**Subject:** **Comprehensive Plan and Zoning Code Amendments for the Old Town Historic Core Overlay, Leary Way, and Gilman Street – Addendum to Technical Committee Report**

## TECHNICAL COMMITTEE REPORT - ADDENDUM

**Date:** April 8, 2016

**Project Name:** Comprehensive Plan and Zoning Code Amendments for the Old Town Historic Core Overlay and for Leary Way and Gilman Street

**Exhibit B: Recommended Amendments to the Redmond Zoning Code**  
**21.62.020.M Historic Core Overlay**

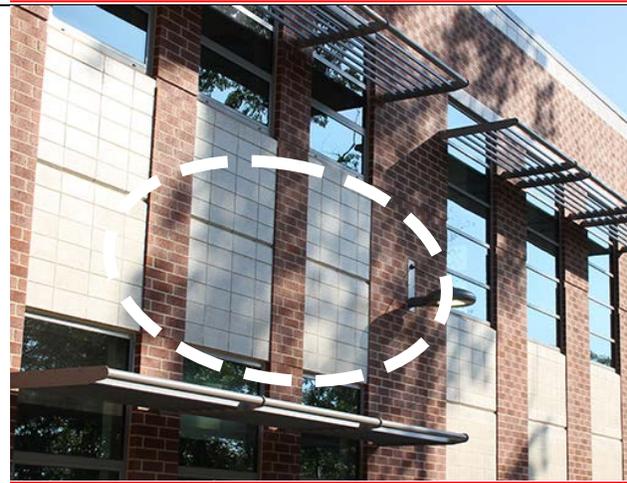
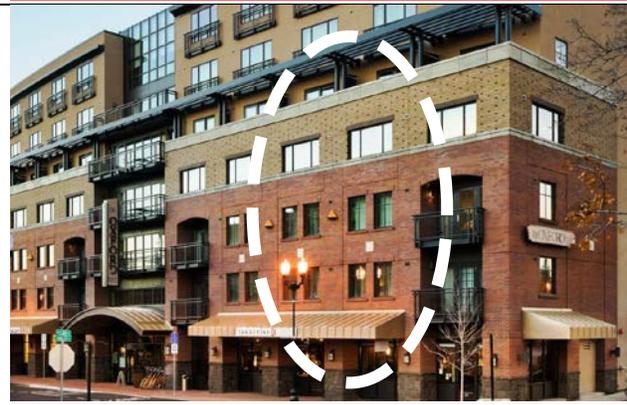
Modern ~~interpretation of historic~~ architecture and design, complements traditional designed through the use of masonry across a majority of the structure and other material. ~~Though clearly a modern interpretation of early 1900 architecture, this~~ This design demonstrates a modern character that is ~~timeless and~~ sympathetic to ~~historic structures within the overlay~~ the Historic Core and an appropriate transition between the first story and upper stories. This design also demonstrates an appropriate use of concrete as an accent to other masonry.

Distinctive masonry incorporates high classifications of brick, stone, and terra cotta. In this example, the design also includes an appropriate use of tile, and concrete. ~~;~~ uses ~~a~~ The variety of positioning, bonds, and joints; and ~~incorporates use~~ unique sculptural elements treatments and finishes at the first through third stories contributes to a high-quality pedestrian experience.

#### 5. Inappropriate Implementation.

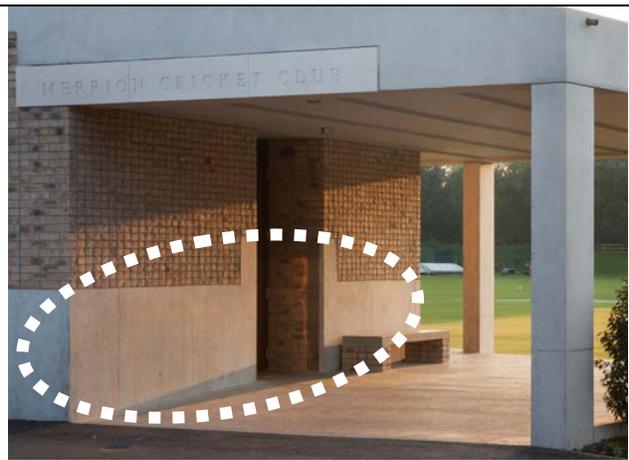
While innovative, the use of modern material such as corrugated metal ~~across a majority of the structure~~ as a primary material does not demonstrate design sympathetic to historic structures within the Historic Core Overlay. Historic structures within the overlay are constructed of brick, wood, stone, and other masonry. Additionally, this design emphasizes a vertical transition thus highlighting the building's height over its width. This design is more modern than traditional and is not appropriate for use in the Historic Core.
